MARK	DATE	DESCRIPTIONS	BY	CH'D	CCO#
2	06/22/07	WELDED PADEYES	NV	TH	41
1	04/20/07	WEST ANCHORAGE ACCESS DETAILS	GB	TH	28

SAN FRANCISCO OAKLAND BAY BRIDGE
EAST SPAN SEISMIC SAFETY PROJECT
SELF-ANCHORED SUSPENSION BRIDGE
(SUPERSTRUCTURE & TOWER)

WEST ANCHORAGE ACCESS DETAILS NO. 3

REQUESTS FOR INFORMATION NOT ADDRESSED IN THIS CCO REMAIN IN FORCE					
2	02/12/08	PADEYE MODIFICATIONS	NV	MN	41
1	06/22/07	WELDED PADEYES	NV	MN	41
MARK	DATE	DESCRIPTIONS	BY	CH'D	CCO#
REVISIONS

WEST ANCHORAGE ACCESS DETAILS NO. 4

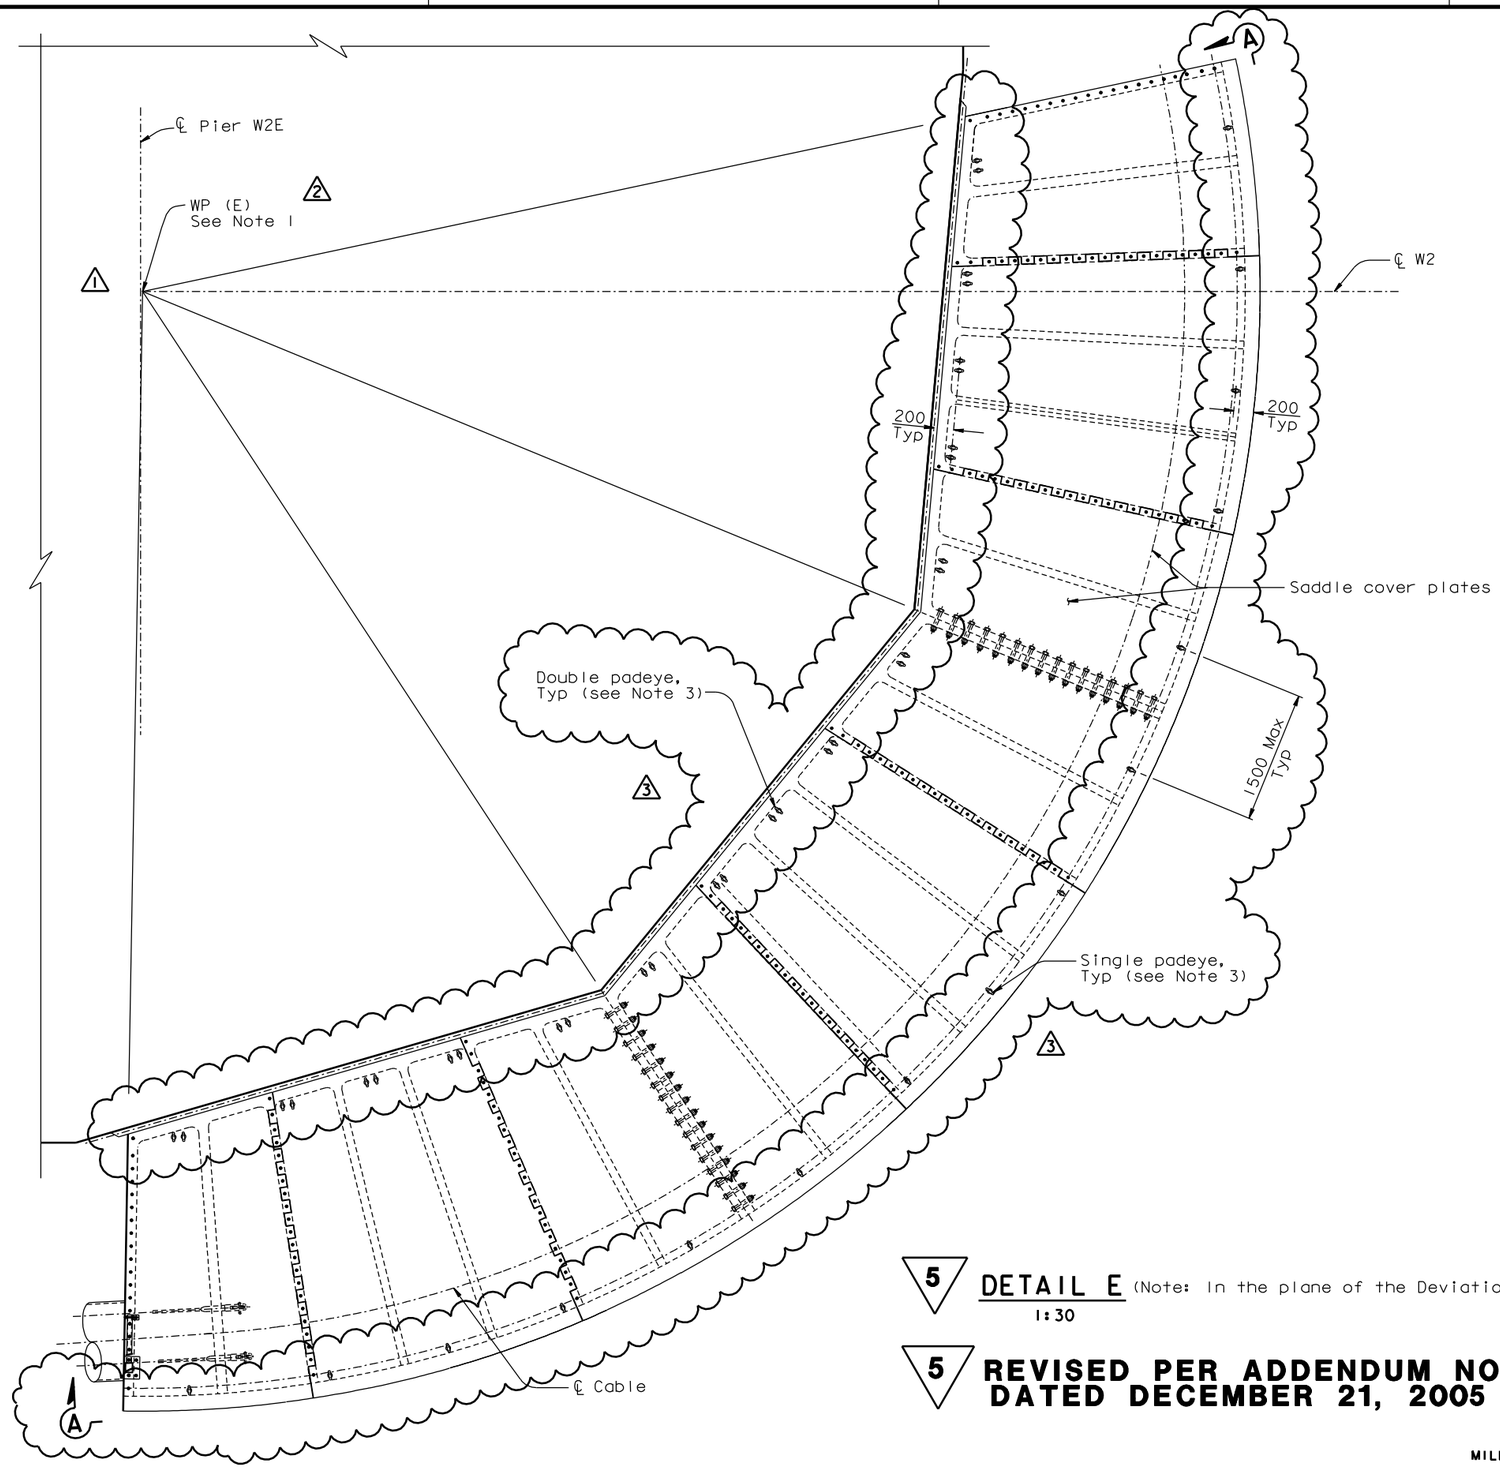
5 **REVISED PER ADDENDUM NO. 5 DATED DECEMBER 21, 2005**

MARK	DATE	DESCRIPTIONS	BY	CH'D	CCO#
3	06/22/07	WELDED PADEYES	NV	TH	41
2	04/20/07	WEST ANCHORAGE ACCESS DETAILS	GB	TH	28
1	01/31/07	WEST DEVIATION SADDLE GEOMETRY	PC	TH	15

1. WP(E) and WP(W) do not coincide with ℄ of Pier W2, ℄ Pier W2E nor ℄ Pier W2W.

3
2. For Section A-A see "West Anchorage Access Details No.5" sheet.
3. For double and single padeye details see "West Anchorage Access Details No.5" sheet.

WEST ANCHORAGE ACCESS DETAILS NO. 5

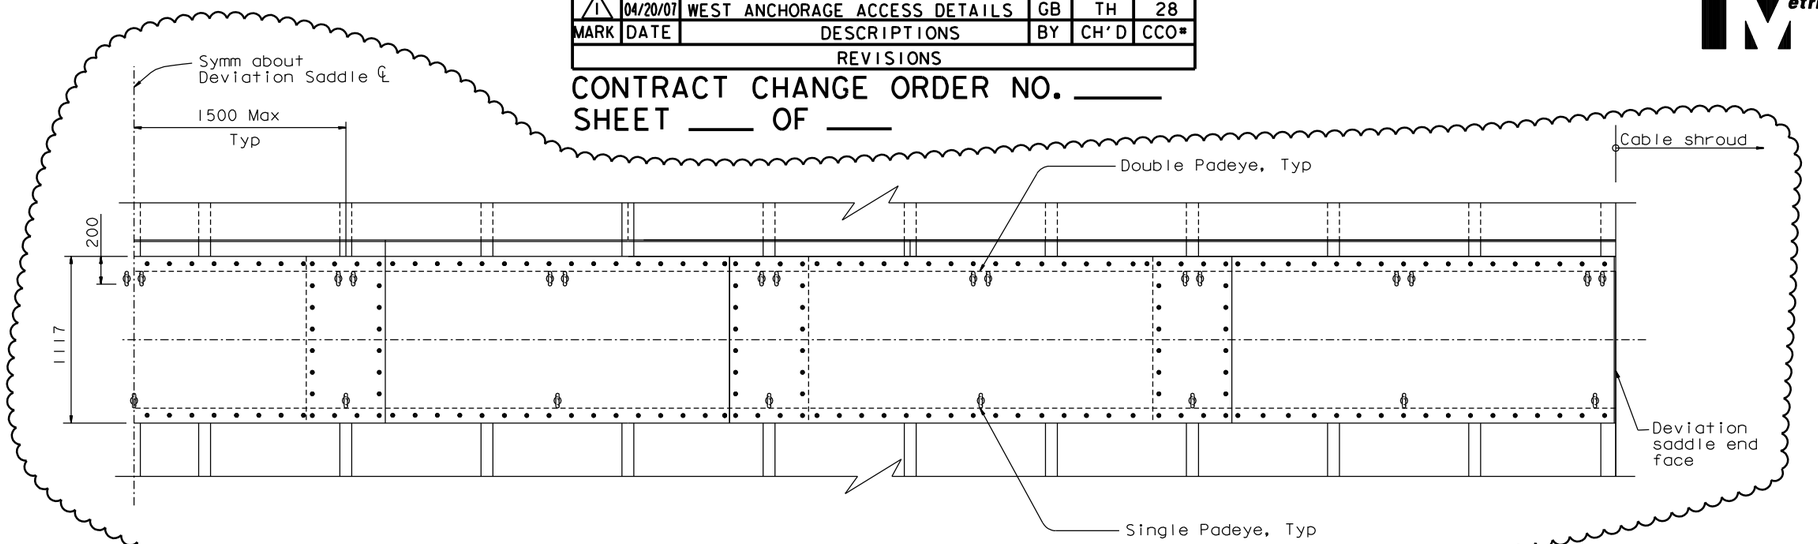
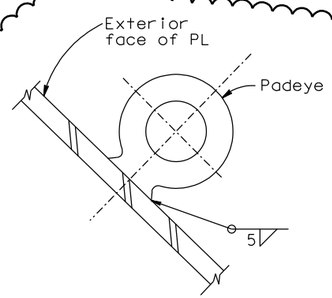
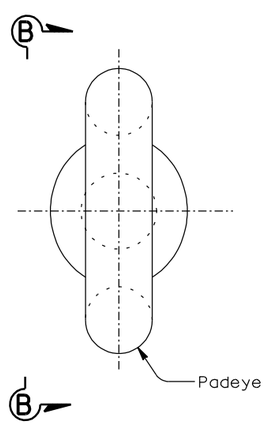
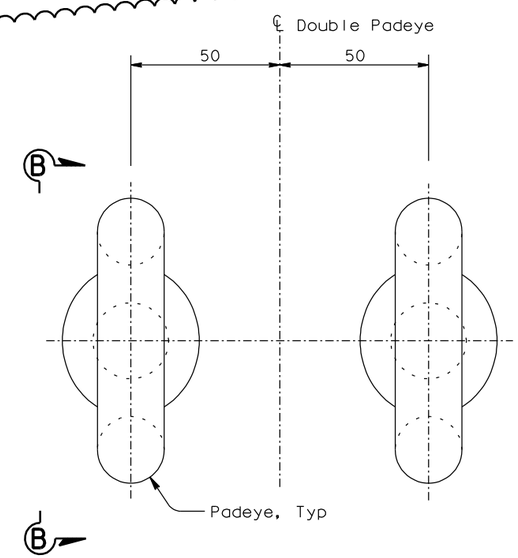
MARK	DATE	DESCRIPTIONS	BY	CH'D	CCO#
2	06/22/07	WELDED PADEYES	NV	TH	41
1	04/20/07	WEST ANCHORAGE ACCESS DETAILS	GB	TH	28

PADEYE LAYOUT AT TOWER HEAD
(For clarity only the pad eyes on tower head PL C are shown)

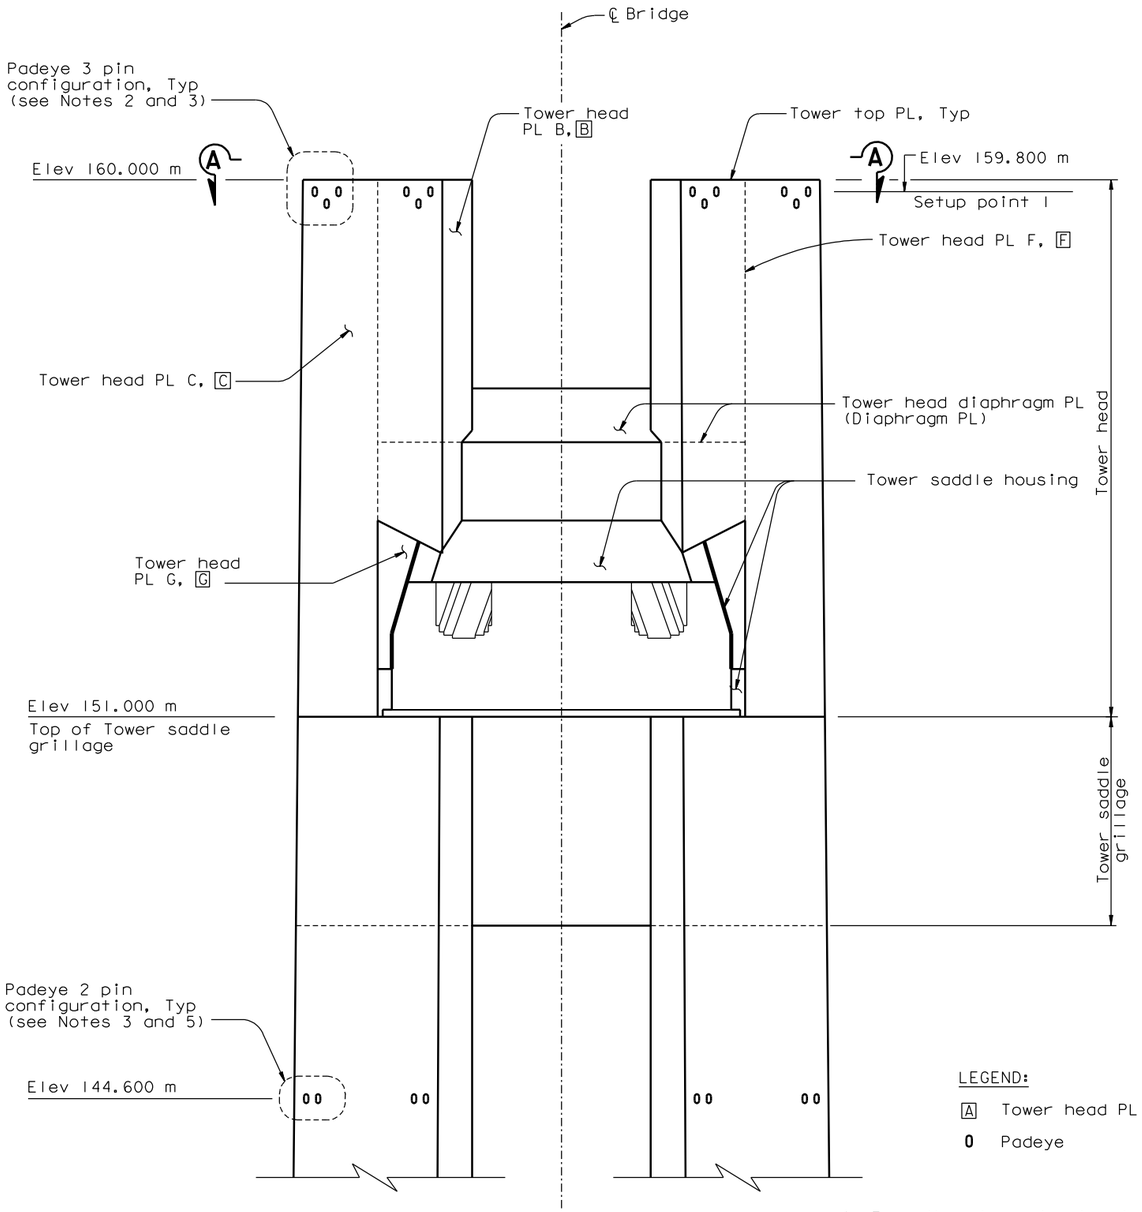
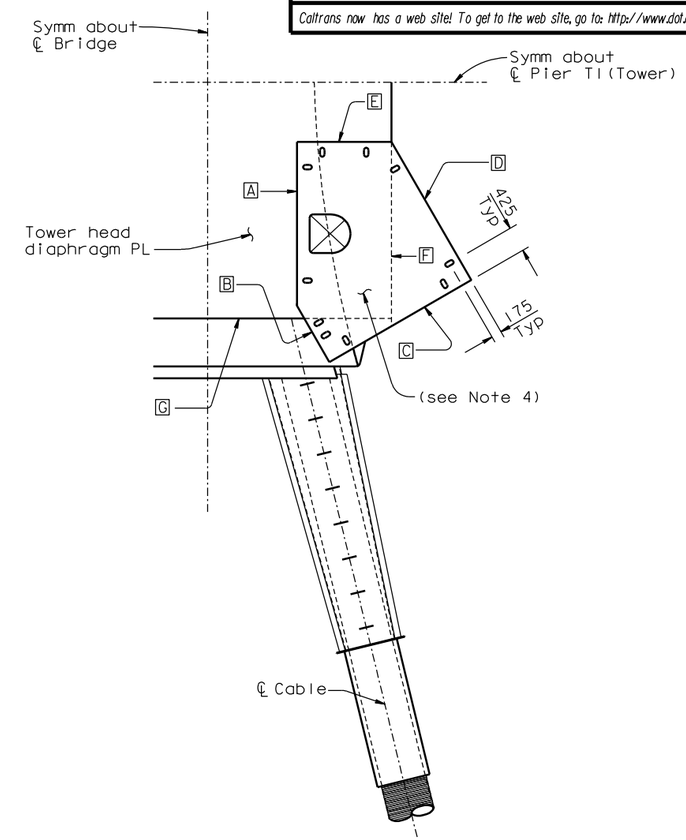
MARK	DATE	DESCRIPTIONS	BY	CH'D	CCO#
1	06/22/07	WELDED PADEYES	NV	MN	41

1. Padeye locations shall be shifted to avoid conflict with tower fog light, boom assembly, outrigger and submitted for approval by the Engineer.
2. Padeye 3 pin configuration shall be located at tower head plate A, B, C, D and E.
3. For padeye pin configuration details, see "Tower Access Details No.22" sheet.
4. For other tower head padeyes, see "Tower Access Details No.13" sheet.
5. For padeye layouts on tower shafts, see "Tower Access Details No.17" sheet.
6. For padeye typical detail and design force, see "Girder Access Details No.10" sheet.

PADEYE LAYOUT AT TOWER STRUT FACADES

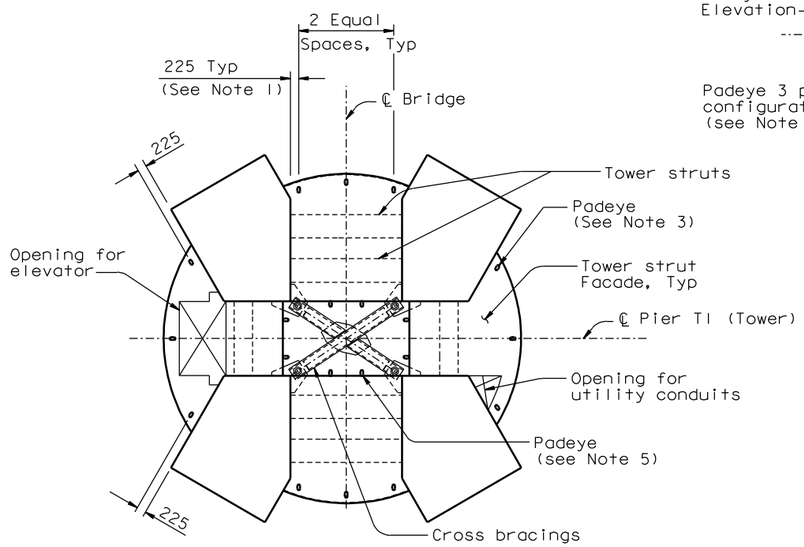
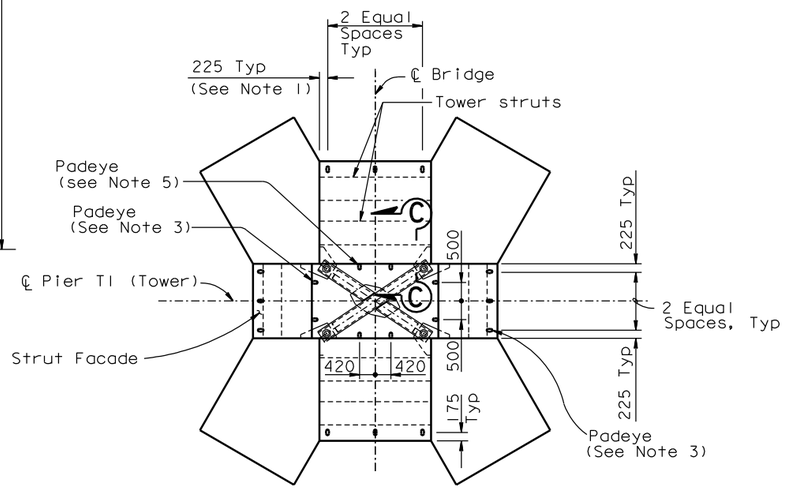
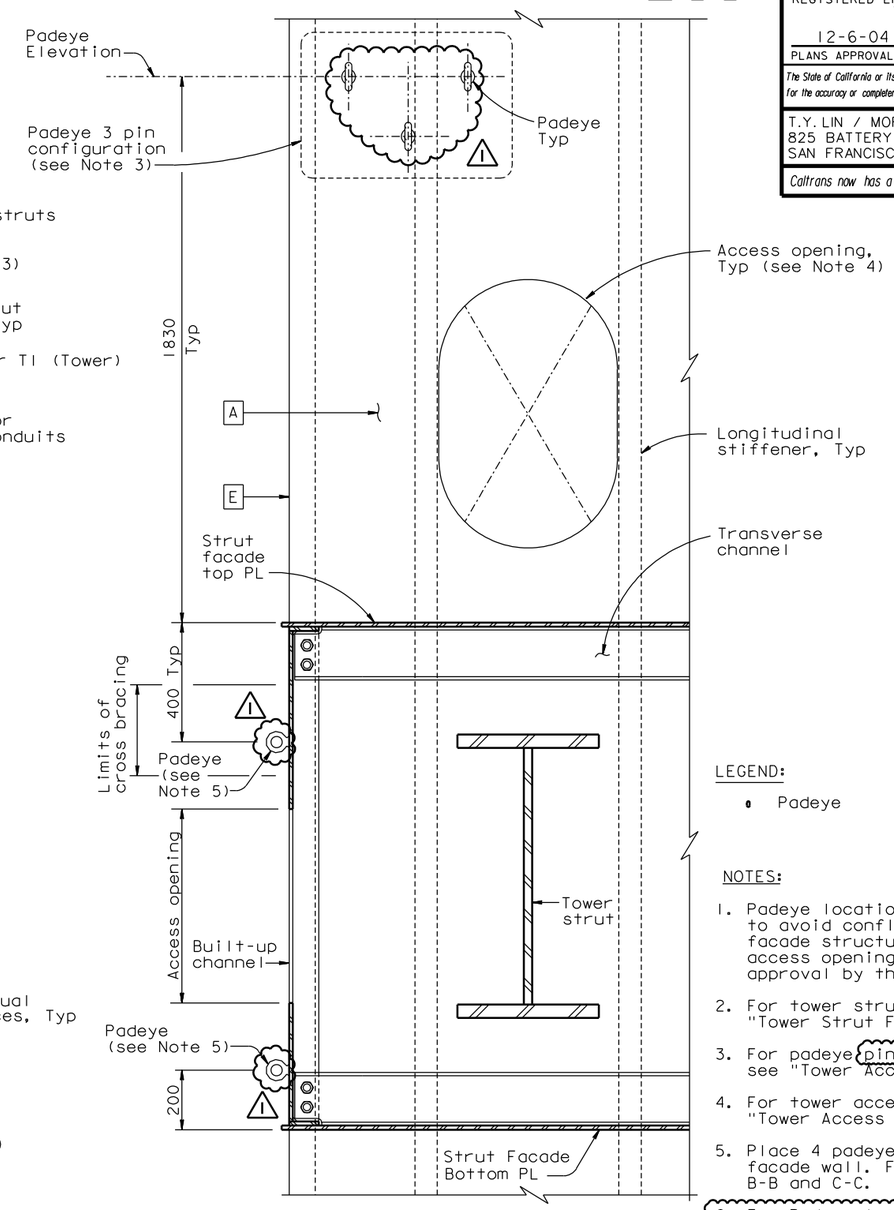
MARK	DATE	DESCRIPTIONS	BY	CH'D	CCO#
1	06/22/07	WELDED PADEYES	NV	MN	41

1. Padeye locations shall be shifted to avoid conflict with tower strut facade structural components and access openings and submitted for approval by the Engineer.
2. For tower strut facade details, see "Tower Strut Facade Details" sheets.
3. For padeye pin configuration details, see "Tower Access Details No. 22" sheet.
4. For tower access opening details, see "Tower Access Details No. 4" sheet.
5. Place 4 padeyes on each inbound strut facade wall. For locations see sections B-B and C-C.
6. For Padeye typical details and design force, see "Girder Access Details No. 10" sheet.

PADEYE CONFIGURATION

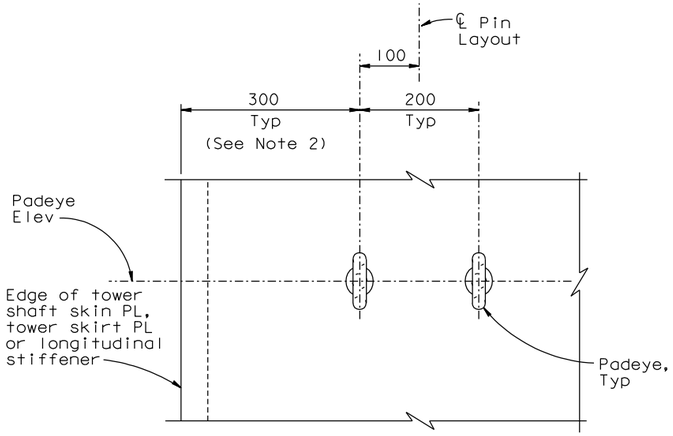
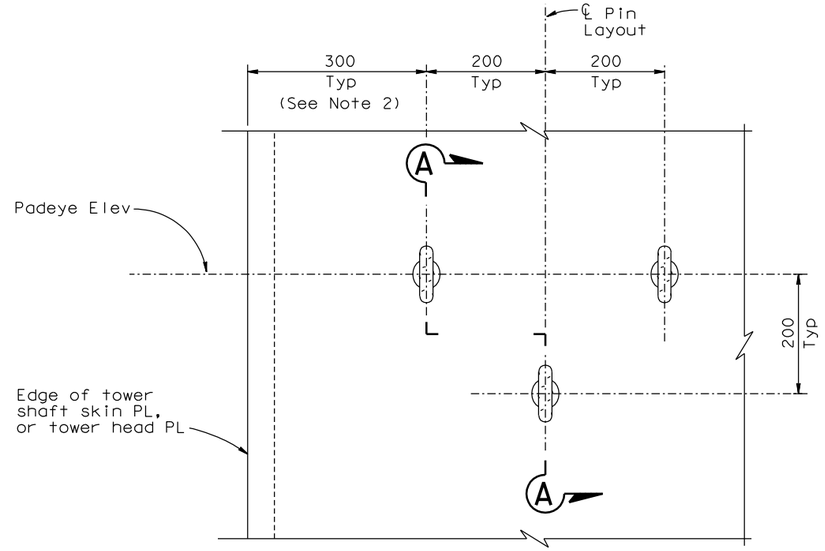
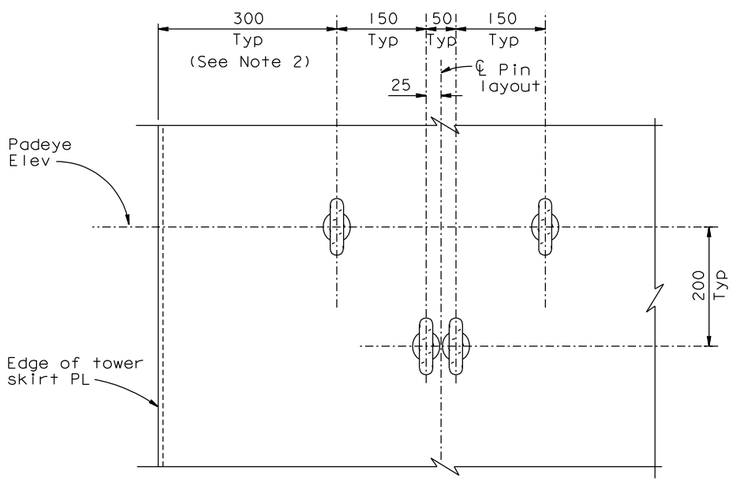
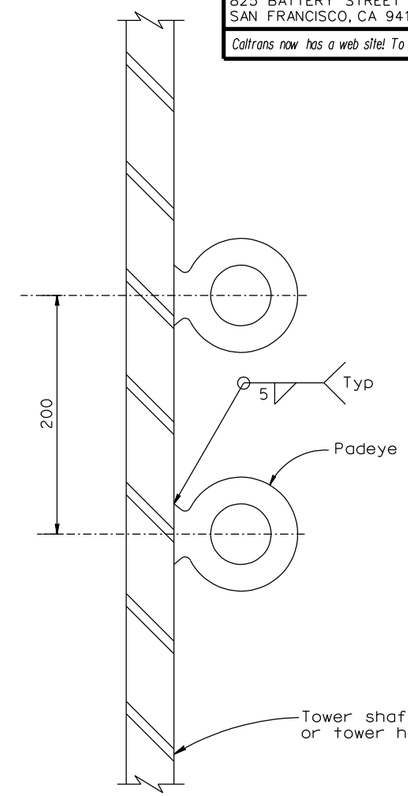
MARK	DATE	DESCRIPTIONS	BY	CH'D	CCO#
3	03/27/09	PADEYE MODIFICATIONS	NV	MN	41
2	02/12/08	PADEYE MODIFICATIONS	NV	MN	41
1	06/22/07	WELDED PADEYES	NV	MN	41

1. For Padeye typical details and design force, see "Girder Access Details No.10" sheet.
2. At corner DE of skin plate D of the southwest shaft, distance from edge to pin configuration shall be increased from 300 mm to 700 mm to provide clearance for mechanical piping.
3. (3) Padeyes on tower skin plate D of the north and west shaft near the D-E corner that are in the path of elevator support attachments may be removed.
